**TO:** Dr. Jesse Bacon, Superintendent  
**FROM:** Danny Clemens, Director of Facilities  
**Date:** July 24, 2025  
**RE:** NBHS Physical Science Center - BG 24-192 - Change Order 11 - BCHS Added Parking Lot **DC**

**CHANGE ORDER INFORMATION:**  
 Change Order Number: 011  
 Date: 07-28-2025

**Change Order Request 16 - PCO #53 - BCHS RFP-20 Adding Parking + BEHS Asphalt Deduct**

**From:** Sam Scudder <Sam@jrconstruct4u.com>  
**Sent:** Friday, July 11, 2025 3:37 PM  
**To:** Lyons, Tonya  
**Cc:** Pittard, Joel  
**Subject:** RFP 20 - Trench drain at Central softball field  
**Attachments:** RFP 3 - combined for print.pdf

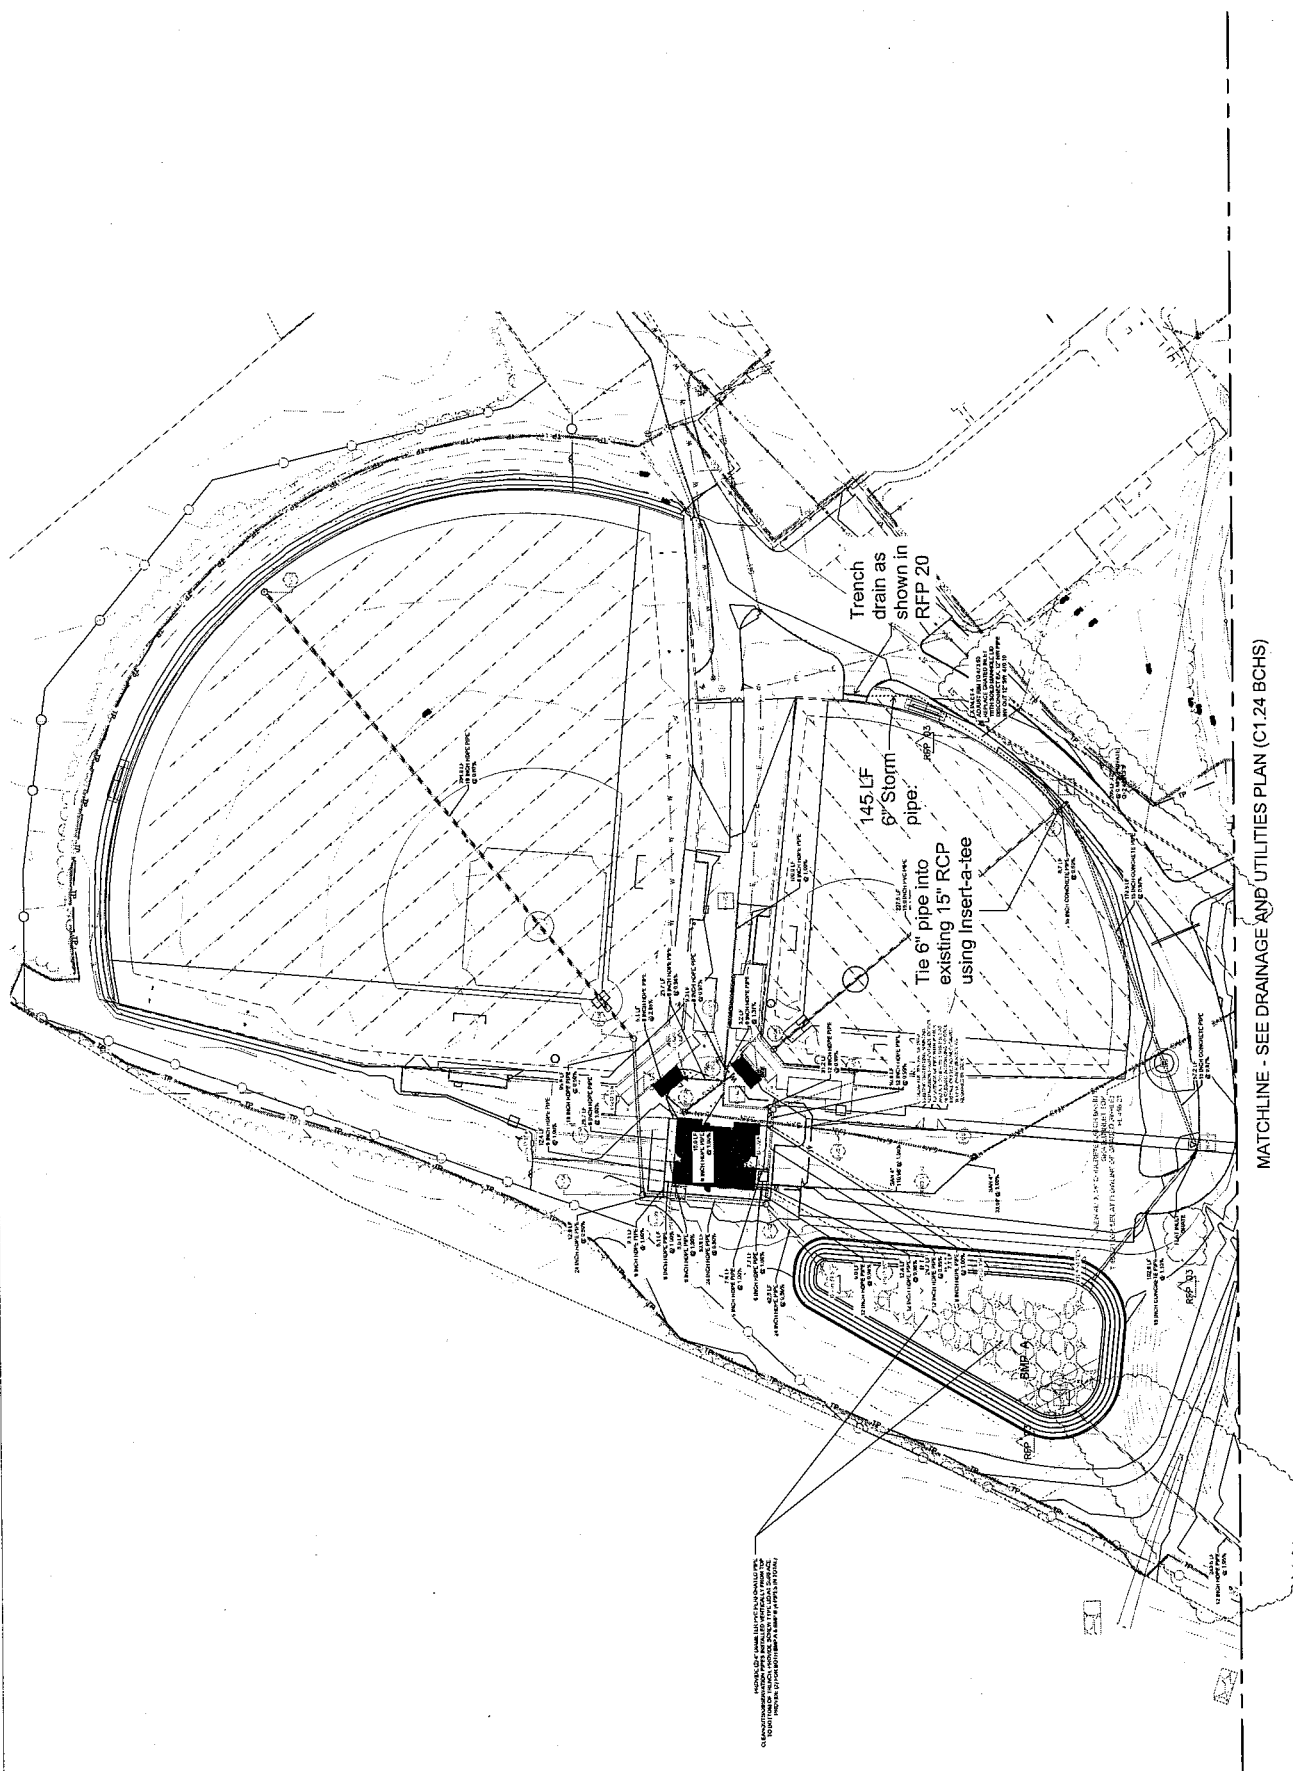
This is the proposed route we discussed. It will miss all known utility conflicts and avoid a fence repair.

- 145 LF 6" pipe @ \$33.28 = \$4825
- Insert-a-tee tie in at 15" RCP = \$850
- 14 LF Trench drain = \$3850
- Asphalt patch at trench drain = \$1500 (price assumed this can piggy back on other asphalt work)
